Metropolitan Planning Commission

Staff Reports

September 11, 2008

2008S-125U-10
 Michalena Subdivision
 Map: 104-16 Parcel: 272
 Subarea 10
 Council District 18 – Keith Durbin

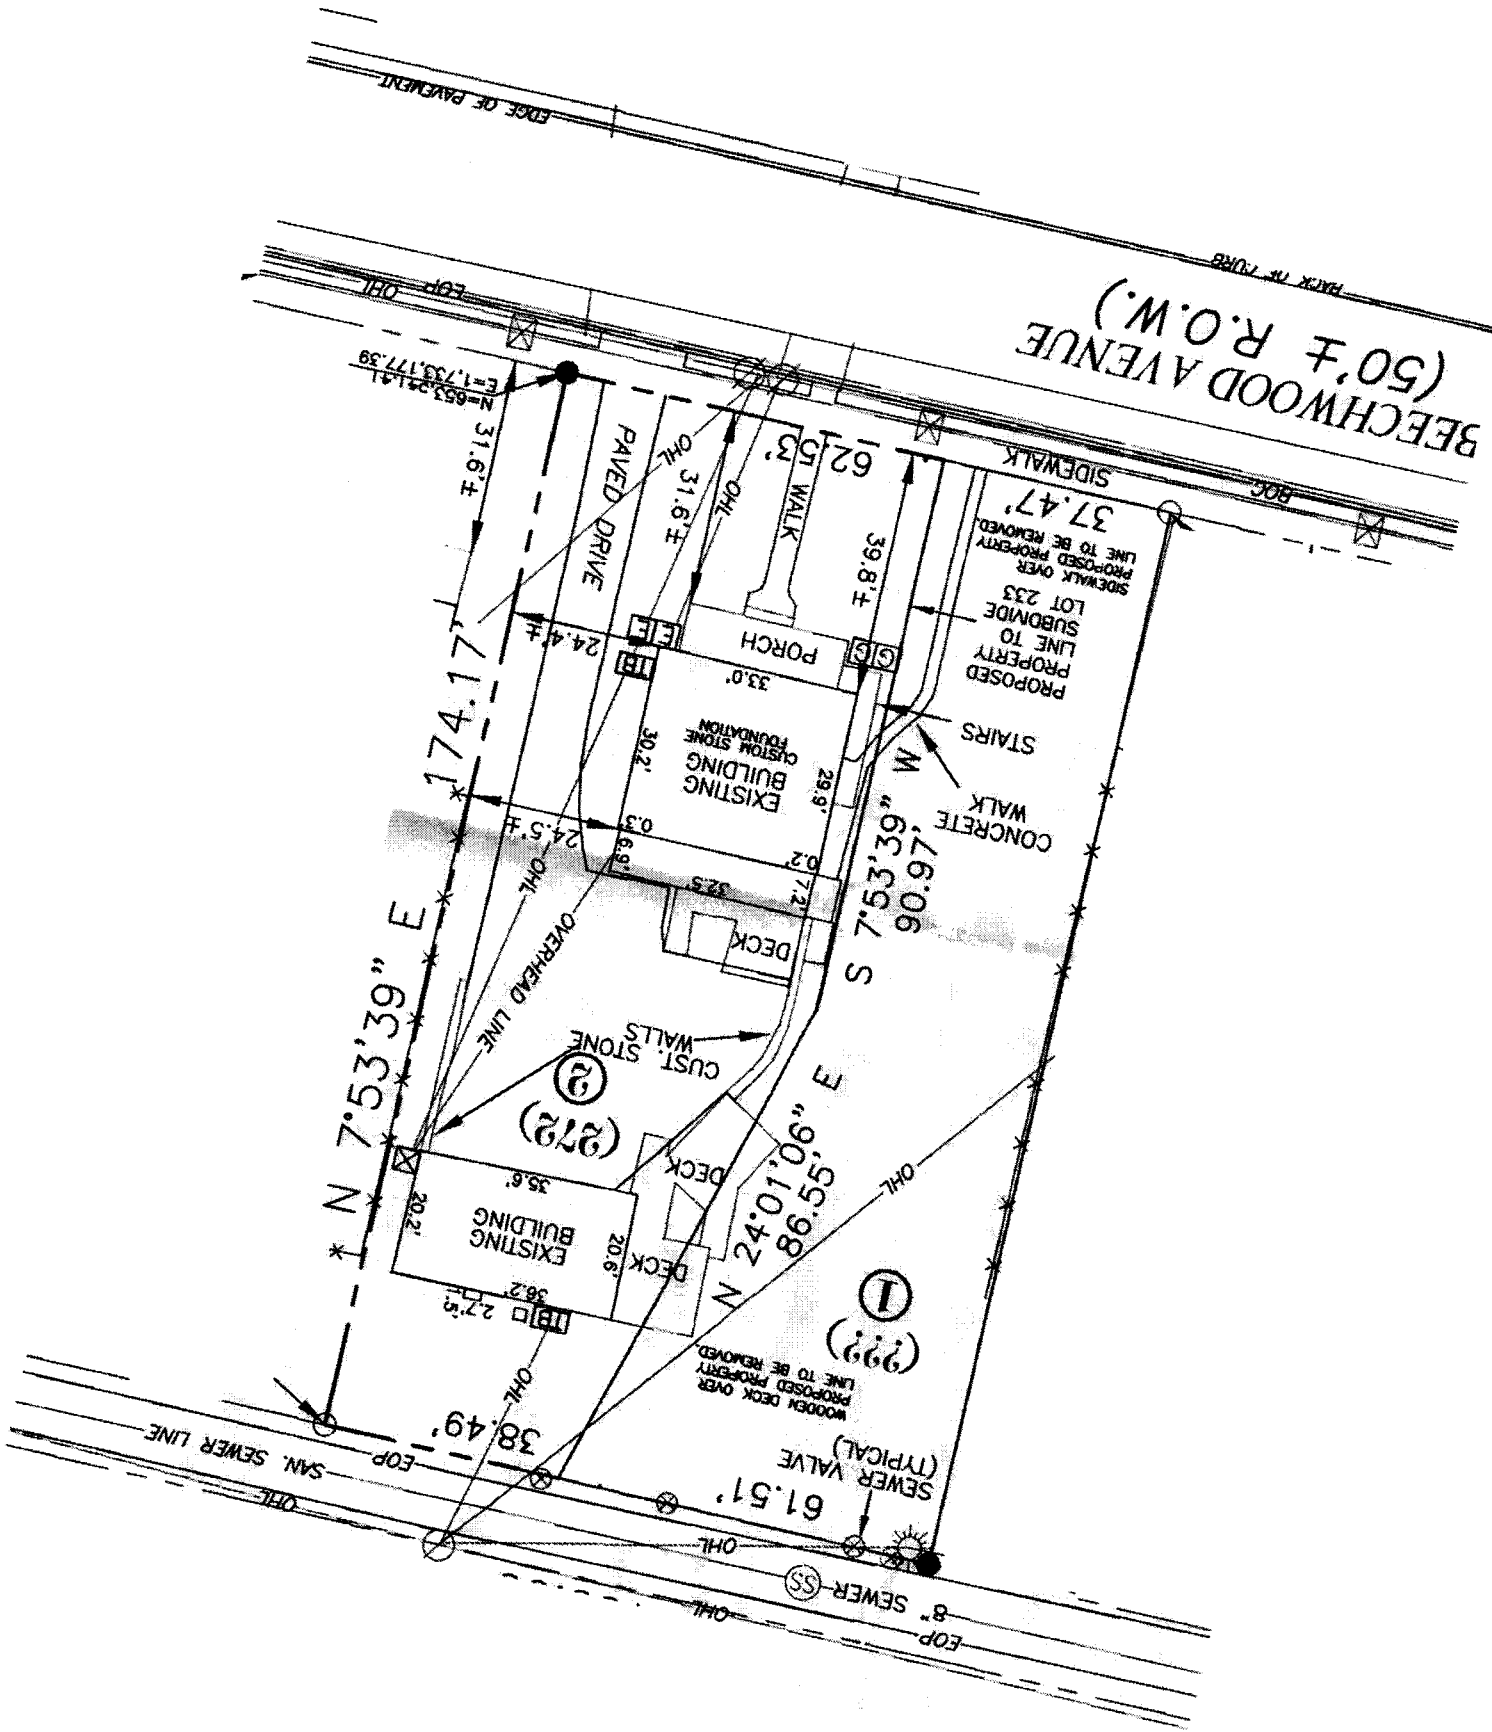
Based on the decision of the MHZC, the applicant submitted a revised plat to allow for a 5 foot side setback to accommodate the existing structure. In order to meet the requirements for minimum lot size the proposed lot line is off-center on the property, with Lot 1 approximately 37 feet wide and Lot 2 approximately 62 feet wide at Beechwood Avenue. At approximately 90 feet the proposed lot line angles toward the west to ensure that Lot 1 is 7,500 square feet in area.

Planning Staff recommends disapproval of the applicant's request for a variance from the lot comparability requirements and the final plat. While the MHZC's decision to not allow the house facing Beechwood Avenue to be moved arguably creates a unique hardship that may support a variance from the comparability requirements, the resulting narrow lot and irregular lot line are not consistent with the overall lot pattern of the area or along Beechwood Avenue.

SITE PLAN
 SCALE: 1/8" = 1'-0"

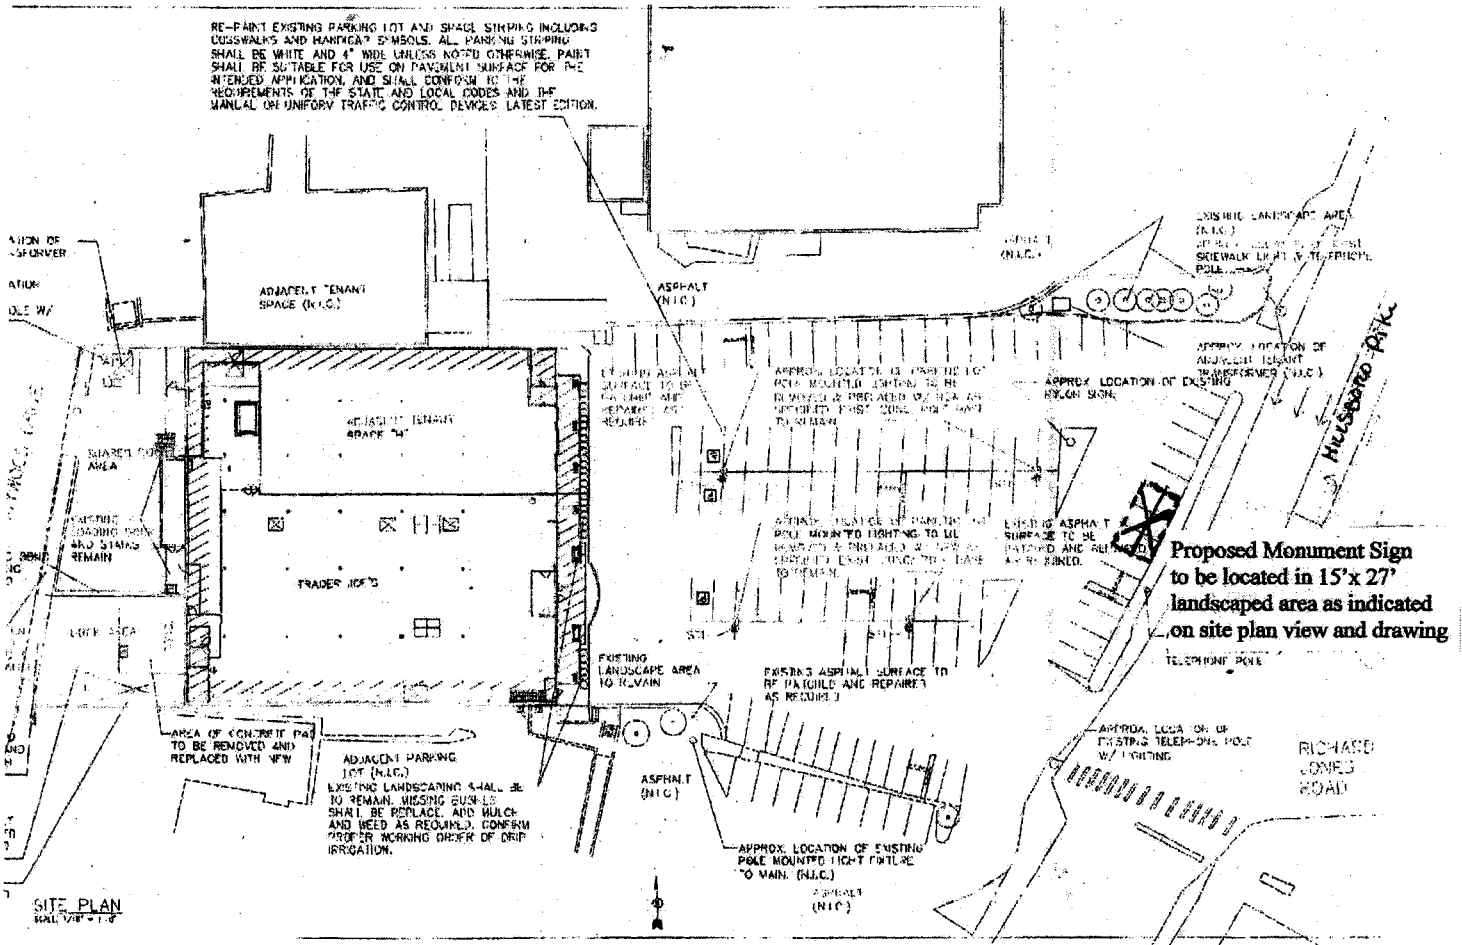
Because these issues can be directly affected by the applicant and are not unique, they are not valid reasons for granting a modification to the Green Hills UDO requirements for this specific property. Regardless of these perceived obstacles to visibility, the intent of the Green Hills UDO is to create a strong pedestrian atmosphere, not to ensure that all ground signs will have unobstructed visibility 100% of the time in all directions.

- The applicant could place a monument sign at each of the two existing driveway entrances. Taking advantage of these two locations would allow for visually unblocked views of signage from each direction on Hillsboro Pike (see “alternative signs” attachment).
- Trader Joe’s could revise the existing parking lot layout to comply with current codes by constructing a 5-foot wide landscaped planter between the front property line and the parking lot. A monument sign could be placed in this area with a lessened chance for visual blockage from vehicles in driveways or on Hillsboro Pike.

Modification of the UDO standards to allow the requested sign would effectively revoke the standards included in the UDO for free-standing signs.

1 Color WEST END AVENUE
1 : 300

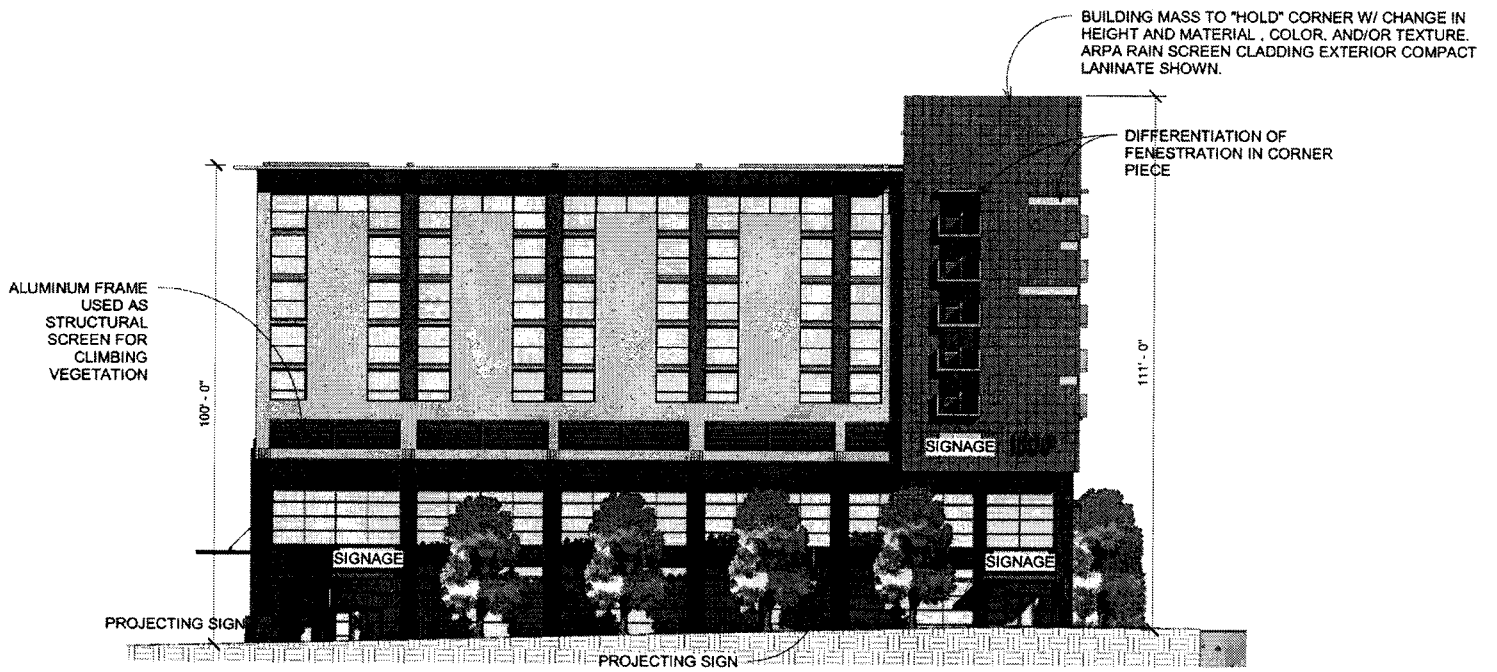
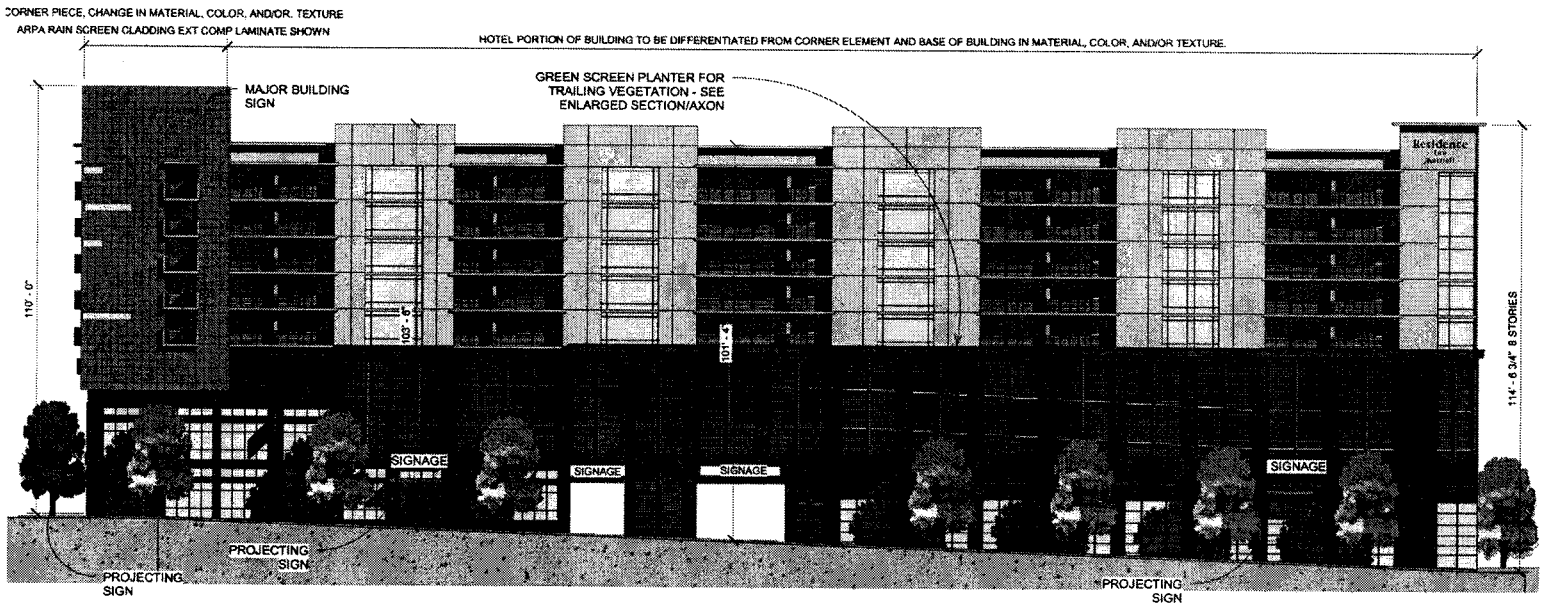
Along 18th Avenue North and Hayes Street the base element and the upper floors are strongly contrasted in form, materials, and the rhythm of materials changes. This contrast may over-emphasize the parking on the elevation. This emphasis could be minimized by extending the rhythm of the upper floors facade down through the parking garage and coordinating materials and colors to be more uniform rather than emphasizing the parking structure on the elevation. Staff recommends that the Commission include a condition of approval that the applicant continue to develop the plans to improve these elements prior to final site plan submittal.

1. The permitted uses for this SP shall include hotel, restaurant and general office/financial institution.
2. Final site plan shall provide an increased sidewalk width along West End Avenue of a minimum of one to two feet.
3. Along 18th Avenue North and Hayes Street the base element and the upper floors are strongly contrasted in form, materials, and the rhythm of materials

changes. This contrast may over-emphasize the parking on the elevation. This emphasis could be minimized by extending the rhythm of the upper floors facade down through the parking garage and coordinating materials and colors to be more uniform rather than emphasizing the parking structure on the elevation. The final site plan shall be modified to de-emphasize the parking on all of the elevations, and to add vertical breaks into the parking and screening areas along West End Avenue.
